ATTACHMENT 3

PROPOSED TECHNICAL SPECIFICATION CHANGES

FOR QUAD-CITIES 1

1.1/2.1 FUEL CLADDING INTEGRITY

FIGURE 2.1-1

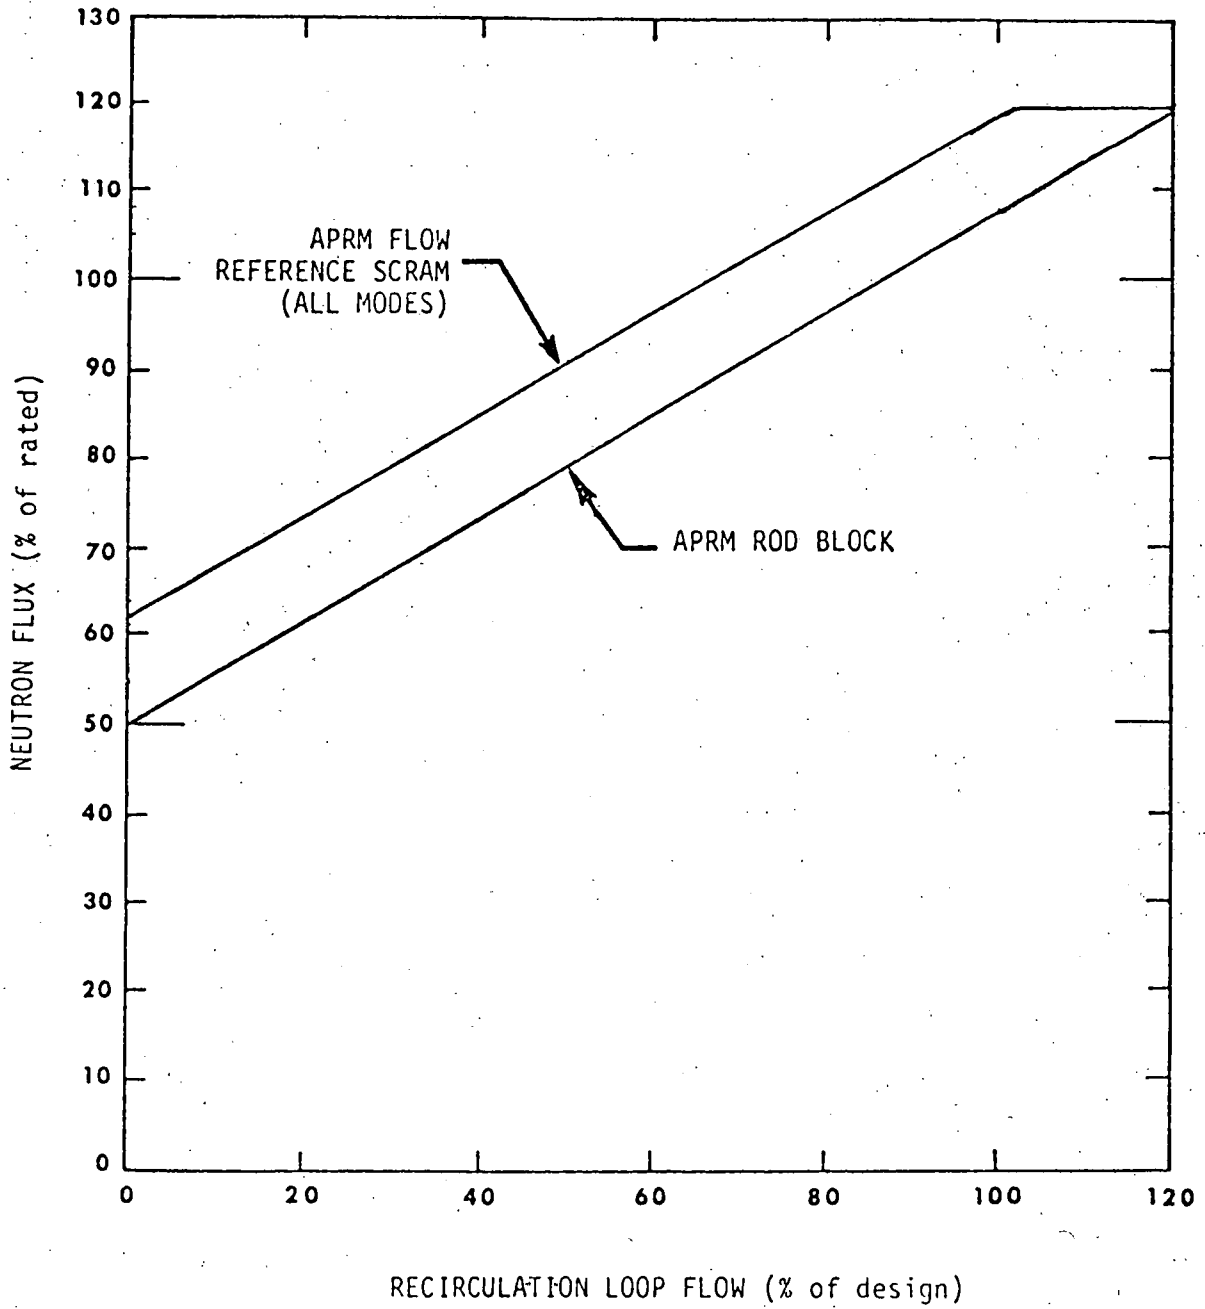
When the reactor mode switch is in the Run position, the APRM flux scram setting shall be as shown in Figure 2.1-1 and shall be:

$$S \leq (58W_D + 62) \quad (LTPF/TPF)$$

The APRM rod block setting shall be as shown in Figure 2.1-1 and shall be:

$$S \leq (.58W_D + 50) (LTPF/TPF)$$
